DD Supporting Evidence: EJP17

Pressure Reduction on Offtakes and PRS

This document provides additional information in response to Ofgem's engineering review comments in Table 34 of the Draft Determination (July 2025) and feedback received at the bilateral on 22nd July 2025. It addresses concerns regarding asset data reconciling to the preferred engineering option, (S08), whole life net benefit and asset health with RIIO-2 spend cap. This response outlines our methodology for forecasting intervention volumes, clarification of asset health scoring and re-framing our preferred option in the context of asset risk.

Modelled Scenarios (S08 chosen; S05 Stable AH; S07 Stable Monetised Risk)

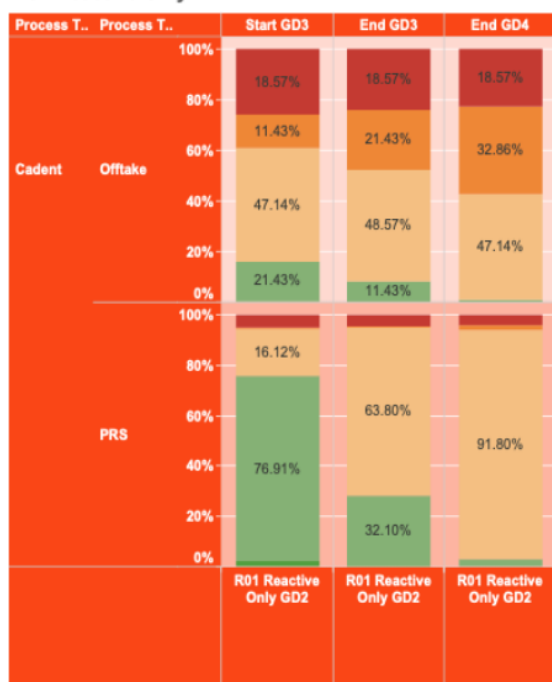
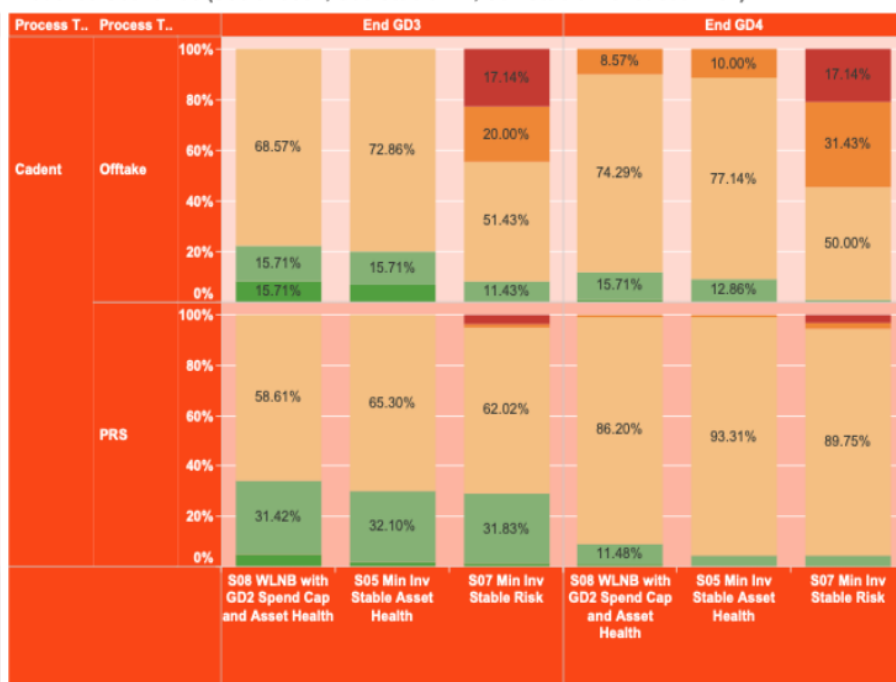
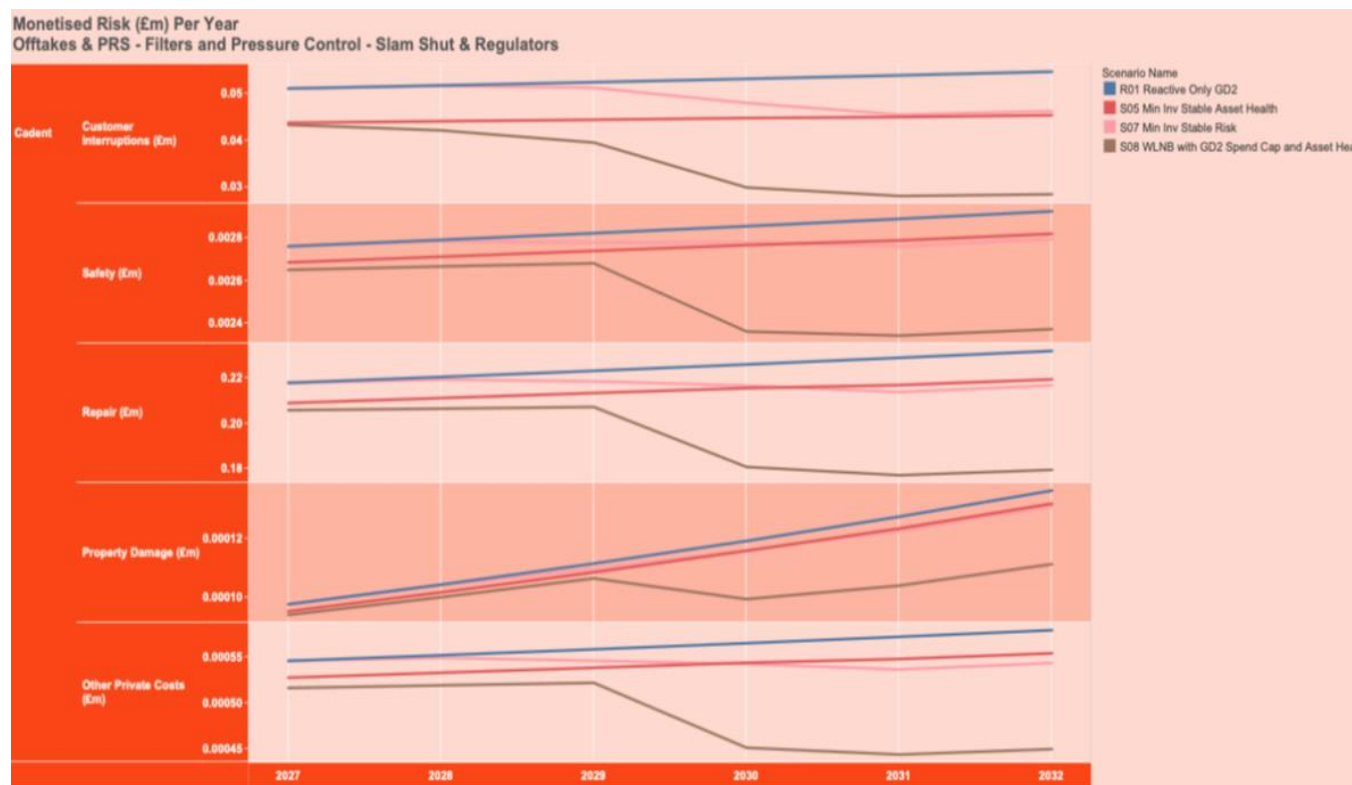
22nd July Ofgem Engineering – Cadent Bilateral	<ul style="list-style-type: none">• Provide information on LTR (long term risk) definitions• Provide average condition scores and stacked bar charts for programme options• Provide further clarity on costs and how they align to our EJP

The above graphic shows how the distribution of asset health grades (1–5), which are explained further on the summary page of EJP17 - DD – DATA – Pressure reduction on offtakes and PRS, for pressure reduction systems changes across the RIIO-3 and RIIO-4 periods, under four of our programme scenarios. Under the reactive only scenario, there is a noticeable shift from assets with better asset health grades (grades 1 and 2) moving to the poorer asset health grades (3, 4, and 5), highlighting the natural deterioration that occurs without any proactive investment, over a 10 year period, out to the end of RIIO-4. Therefore, the CAPEX that would be required to stabilise asset health or return to RIIO-2 end health position would be significant.

Our S08 programme scenario (WLNb and asset health within a RIIO-2 spend cap), demonstrates a more balanced asset health distribution, with a slower rate of declining asset health and a greater proportion of assets remaining in asset health grades 1-3, with all 4's and 5's being removed. Whilst asset health score 4's are present by the end of RIIO-4, our preferred option has a smaller number of 4's, and a greater proportion of 1's and 2's.

S05 is comparable at end RIIO-3 to S08 and cost less however looking to RIIO-4 we see S08 offers a 'healthier' asset base. In RIIO-3 we have a focus on unsupported flow control valves on offtakes and due to the size and complexity of these sites there is an increased cost to manage the risk, which is why there is a delta in spend between S05 and S08. If we did not address these assets on critical sites in RIIO-3, we expect the capex required in RIIO-4 to increase to address asset health grades 3 & 4 deteriorating assets on top of the uninvested asset health grades 4 & 5 in the S08 scenario to manage the risk on our offtakes. Additionally, under S08, there is a higher likelihood that we will have to reactively intervene and/or increase maintenance/ monitoring at these sites, for which spares, and soft parts are no longer supported by manufacturers at these sites which would likely cost more than the current S05/S08 spend difference.

The stable risk scenario (S07), although maintaining overall monetised risk, allows asset health to degrade in a similar way to the reactive only approach (R01), demonstrating that stabilising monetised risk does not equate to maintaining physical asset health.

Overall, the graphic supports the case that targeted investment, as seen in our preferred S08 scenario, helps slow deterioration. It also underlines that stable monetised risk strategies may obscure underlying asset deterioration, leading to future spikes in capital expenditure to restore asset health and integrity.
